RESOLUTION SETTING HEARING ON REQUEST FROM CASEY'S MARKETING COMPANY (OWNER), REPRESENTED BY MELANI SAMORA (AGENT), TO REZONE PROPERTY LOCATED AT 4560 AND 4570 EAST 14TH STREET

(ZON2014-00215)

STAFF REPORT TO THE PLANNING COMMISSION

SHEET: PLAN MAP

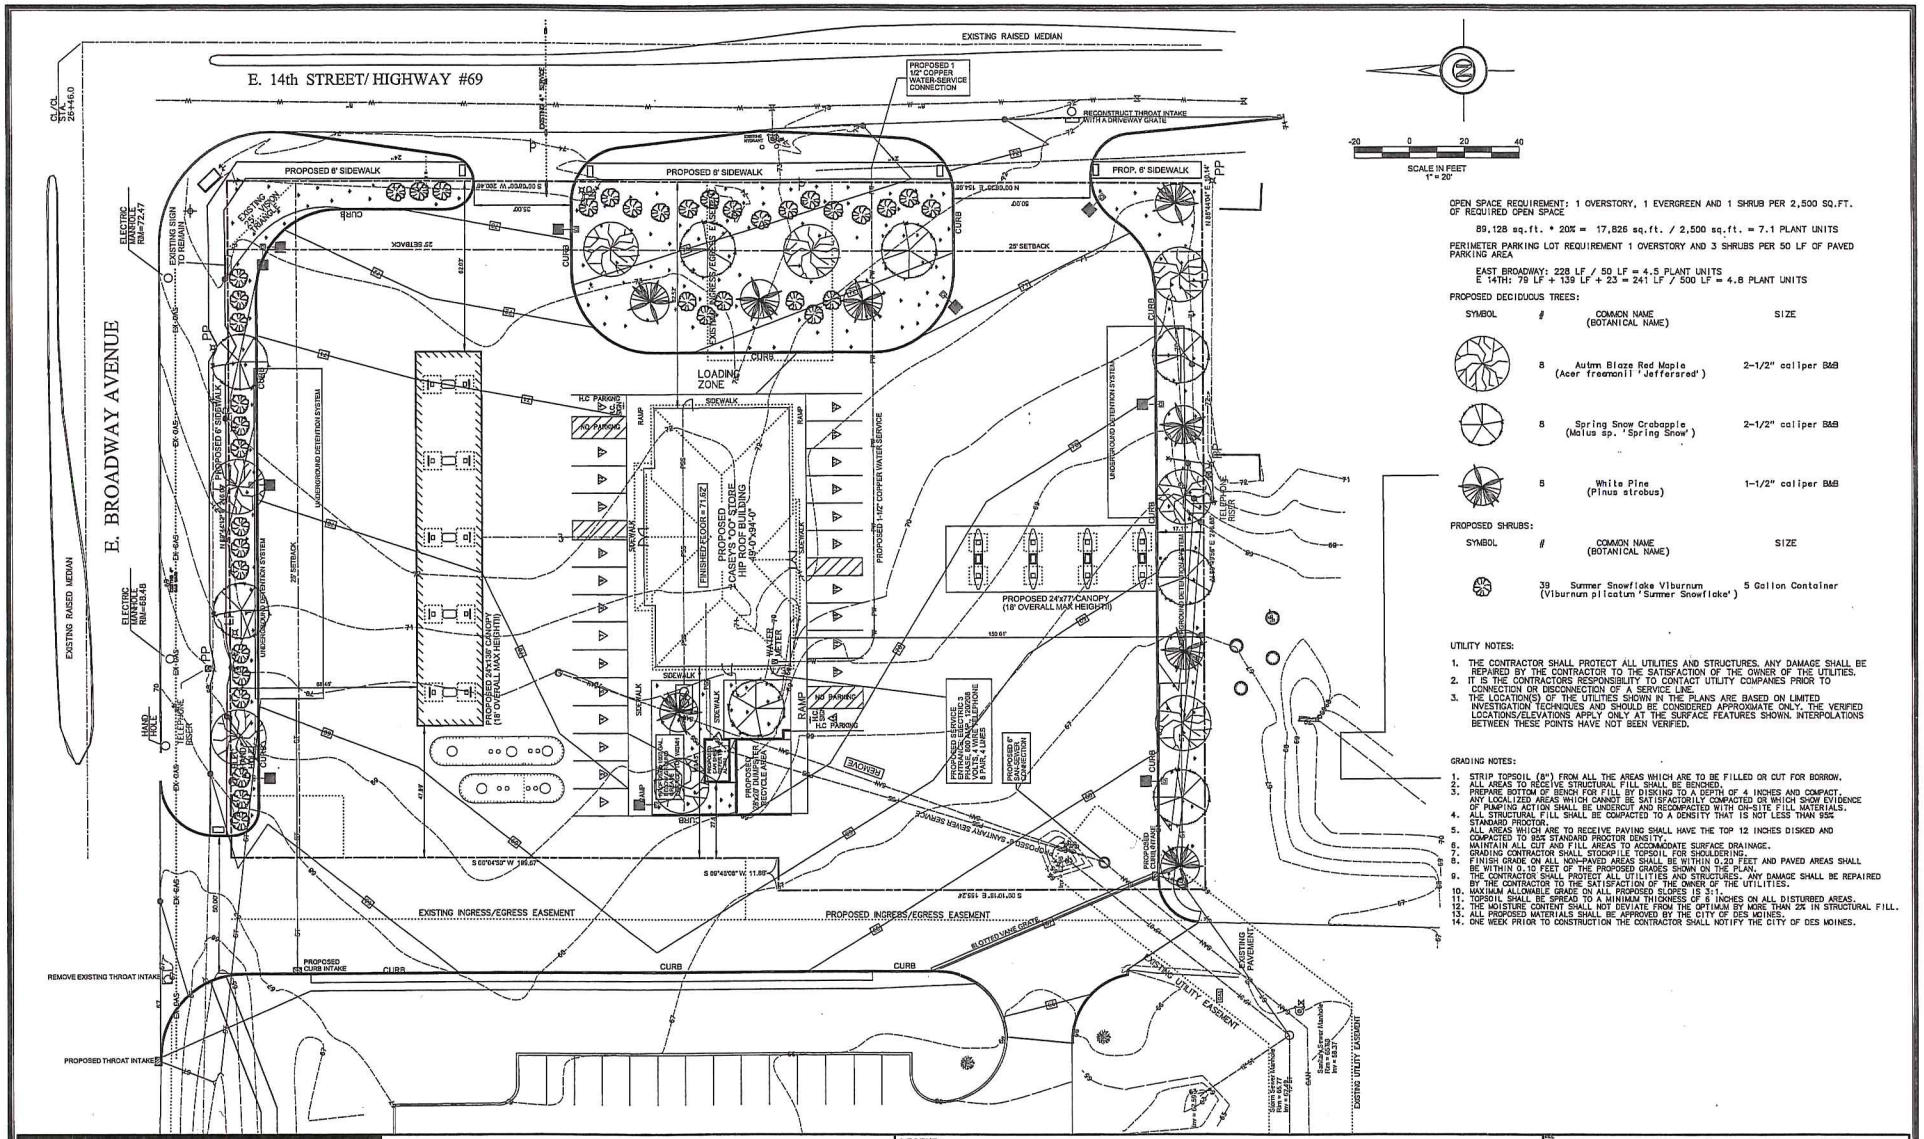
1) The number of driveway entrances to East 14th Street shall be reduced to one, unless Traffic and Transportation and IDOT approves a second access as part of development plan.

4. **Traffic/Parking:** Comments from the Traffic Engineering staff indicate that access off of East 14th Street to this site should be limited to a single driveway entrance. East 14th Street is a state highway with higher speed traffic flows, so additional conflict points should be minimized. A driveway approach width somewhat larger than our 35-foot maximum standard to accommodate the anticipate truck traffic could be acceptable for this site. The design for the approach could include a radius larger than normal, instead of the tapers shown on the submitted Conceptual Plan. Iowa DOT would also have to approve any changes to the single driveway access that is currently allowed at this Casey's Store location.

The subject site is located on the southwest corner of the East Broadway Avenue and East 14th Street intersection. The submitted Conceptual Plan proposes two access points to East 14th Street and a single access point to East Broadway Avenue via a shared driveway with the properties to the south and west. Traffic Engineering staff have recommended that there be only a single drive entrance off of East 14th Street, with consideration for a wider drive than is typically allowed.

The Conceptual Plan shows public sidewalks along East Broadway Avenue and East 14th Street. No direct sidewalk connections are provided from these walks to the building. Staff recommends a sidewalk connection from the East 14th Street sidewalk be provided. Staff also believes that an identified pedestrian route needs to be proved from the East Broadway Avenue sidewalk and/or from the shared access drive to the west. This could be accomplished with paint or special paving treatment. All of the proposed parking spaces have access to pedestrian routes adjoining the primary building.

The Conceptual Plan shows a mix of trees, evergreens and shrubs throughout the site. The conceptual landscaping plantings should be shown at minimums that would be necessary for "C-2" Districts. This would require 5 overstory trees and 15 shrubs along the north perimeter lot, 5 overstory trees and 15 shrubs along the east perimeter lot, and 7 overstory trees, 7 evergreen trees and 7 shrubs within the open space areas. Up to 30% of the plant material may be substituted in accordance with the substitution ratio in the City's Landscaping Standards. The plant material types shown on the Conceptual Plan do not demonstrate intent to comply with the "C-2" Standards. Staff recommends that a note be added into the PUD Standards that all landscaping will comply with minimums that would be required in a "C-2" District.

Front Building Elevation (Plan South) 2

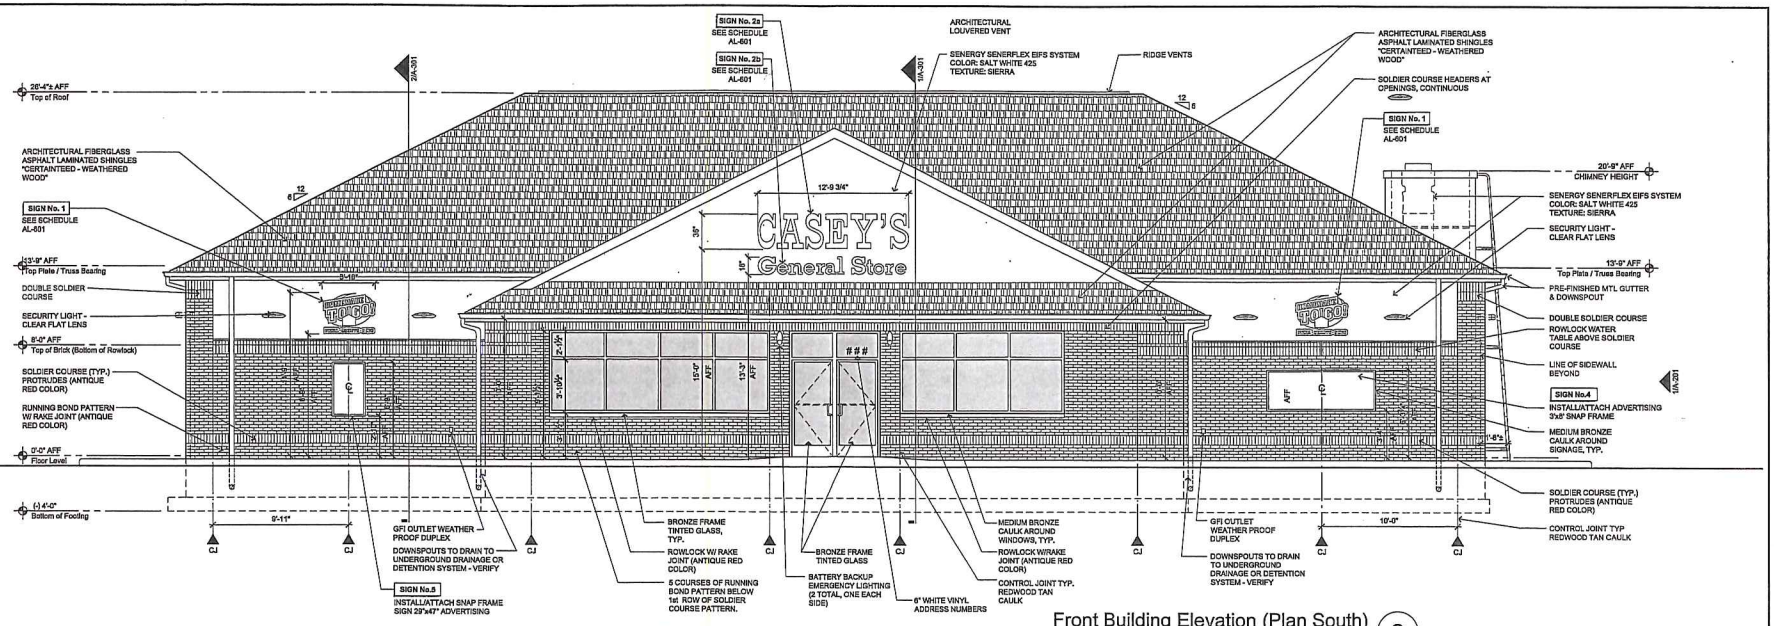
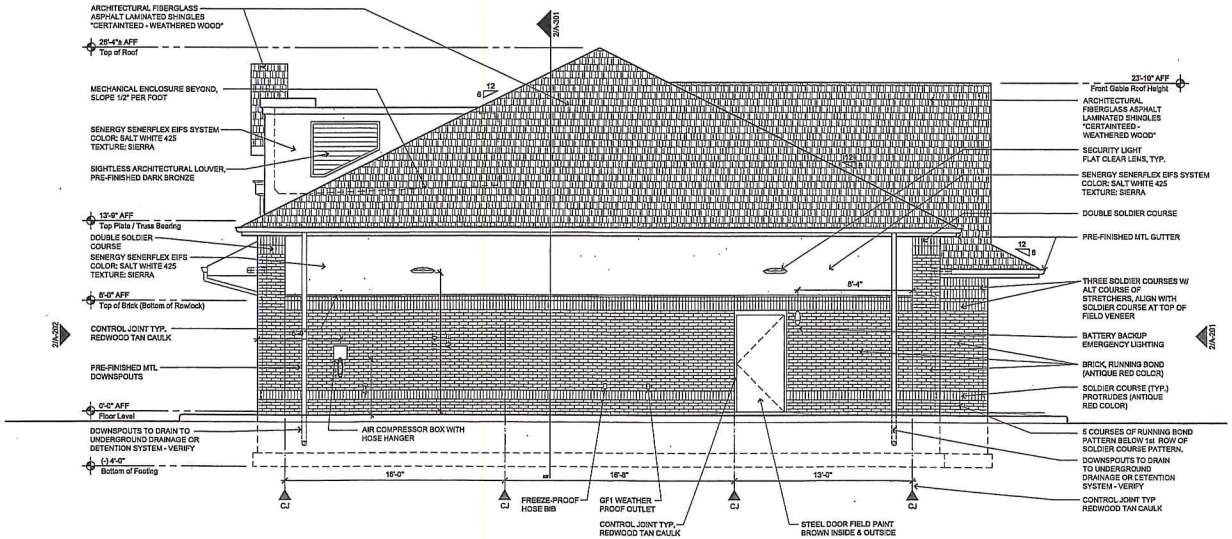
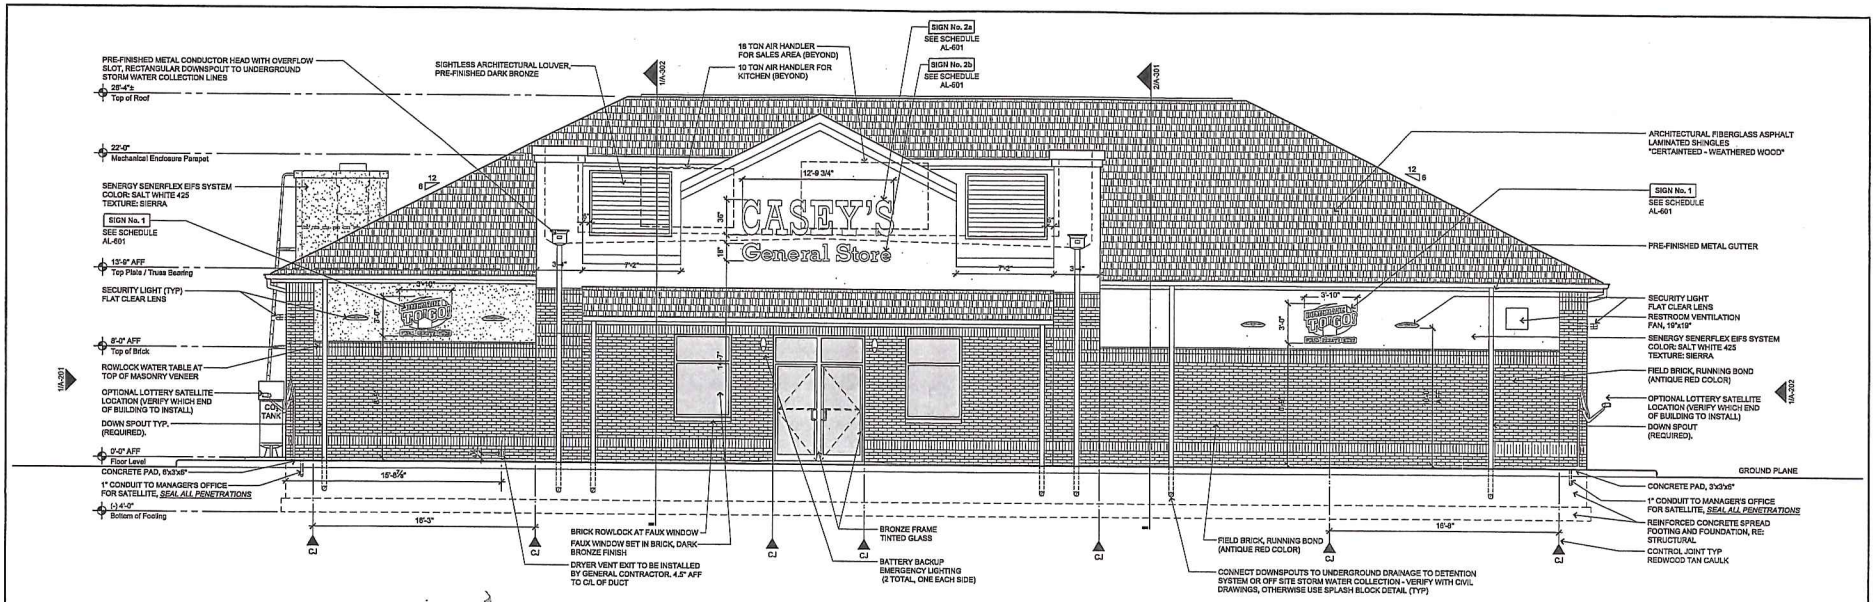
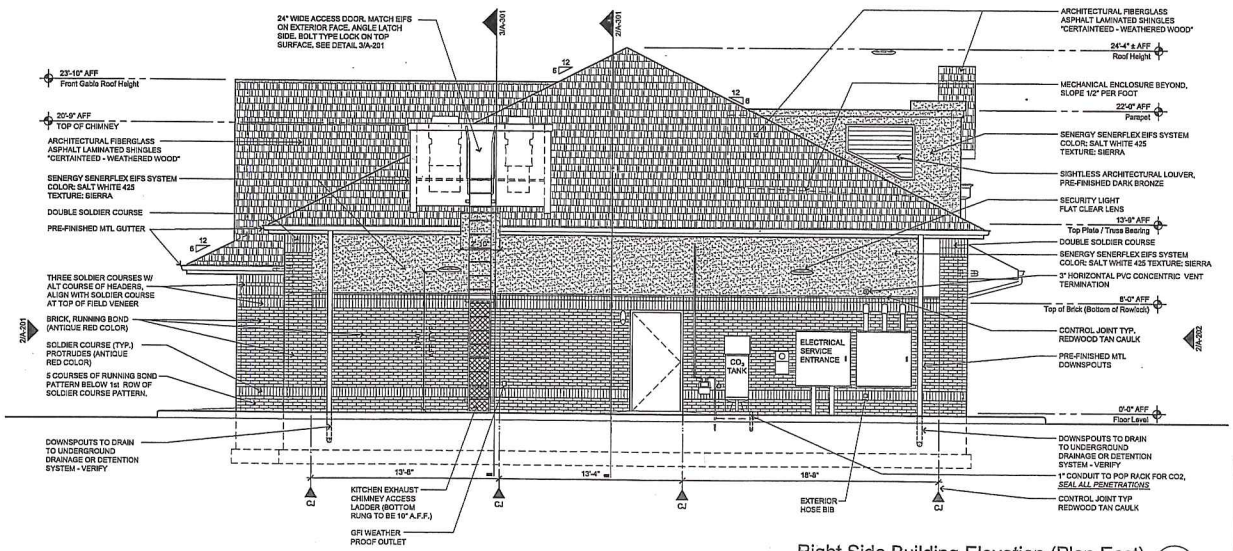
5) A sign allowance table shall be defined and provided on the building elevations or a separate sign plan sheet, to include size dimensions and a key to their locations.

The proposed building would be sided with brick would have EIFS accents. Solider course treatment would be used to add visual interest to the building. The building would have hipped and gable roof elements and architectural asphalt shingles. The primary façade would be oriented to East Broadway Avenue with a secondary entrance oriented towards the south. No entrance or windows are proposed on the east façade facing East 14th Street. Normally, for the project to be eligible for tax abatement, the façades oriented toward East Broadway Avenue and East 14th Street would need to be modified to provide 20% window and door openings. Staff believes that the proposed building design is appropriate in this setting. The area is made up of light industrial uses with substantial tractor-trailer traffic and has a strong, auto-orientated character. Given this character, staff believes that windows and/or an entrance facing East 14th Street is not necessary.

4 Front Elevation 1/2" = 1'0"

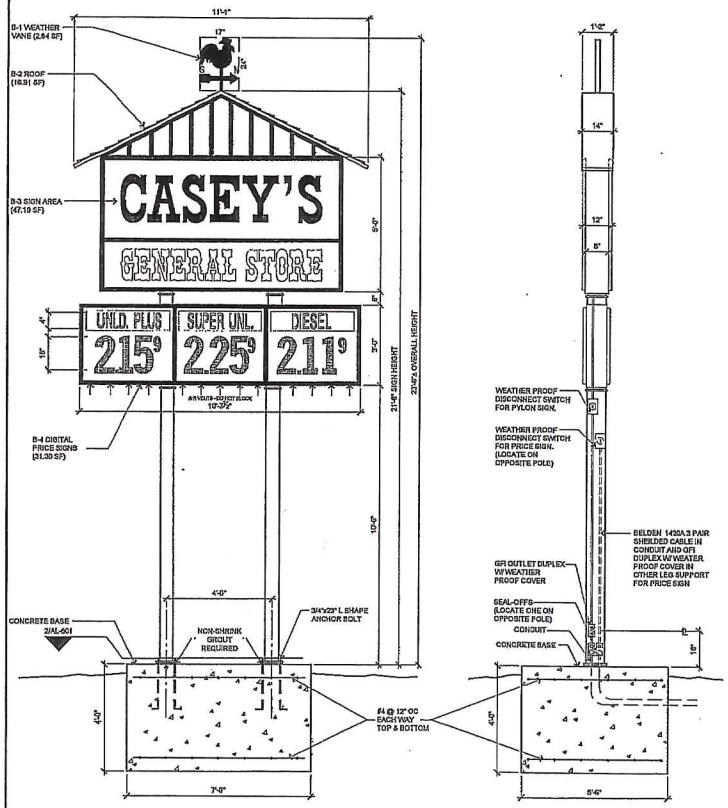
6) Elimination of the existing pole sign. Any freestanding signs shall be monument signs with an approved sign elevation sheet as part of any PUD Conceptual Plan. Freestanding monument signs within 25 feet of the Right-Of-Way shall not exceed 12 feet in height and with all other freestanding monument signs not to exceed 15 feet in height if setback more than 25 feet.

Wally Pelds stated they would probably not want to lower the sign. He would ask for a variance if he had too. There have been no complaints about the sign and they would like to keep it where it is, dress it up with digital display on the bottom so they can change the fuel price numbers.

4 Pump Island Canopy - (Street Side)
1/8" = 1'-0"

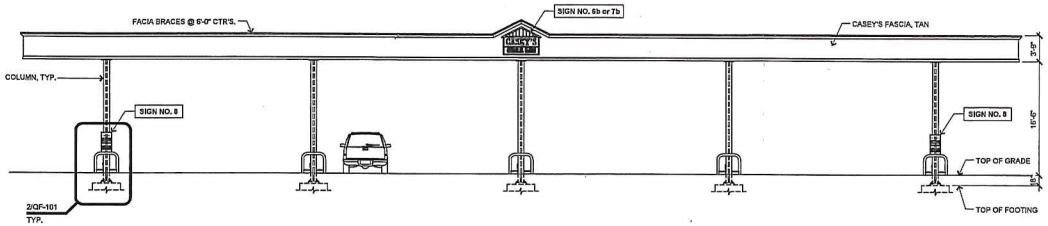
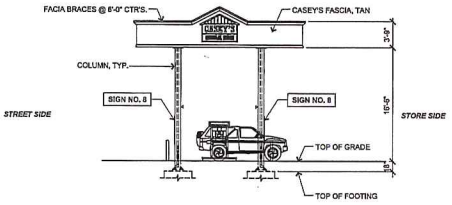
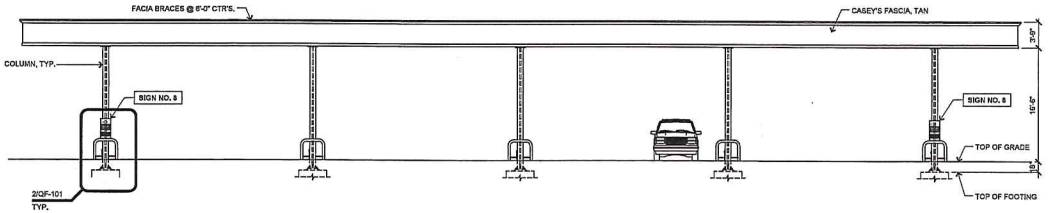
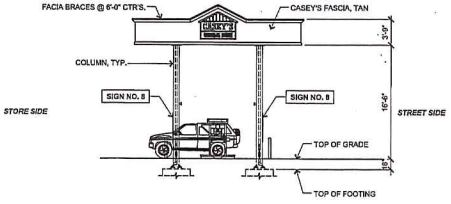
4) Provision of a canopy design elevations demonstrating compliance with all design guidelines for gas stations/convenience stores including flush mounted lighting and support columns that are clad in masonry material to match the primary building. Overall canopy heights should not exceed 22 feet inclusive of sign elements. All proposed canopy sign allowances shall be included on the elevations or with an overall sign plan sheet.

support columns that are clad in masonry material to match the primary building. Overall canopy heights should not exceed 22 feet inclusive of sign elements. All proposed canopy sign allowances shall be included on the elevations or with an overall sign plan sheet.
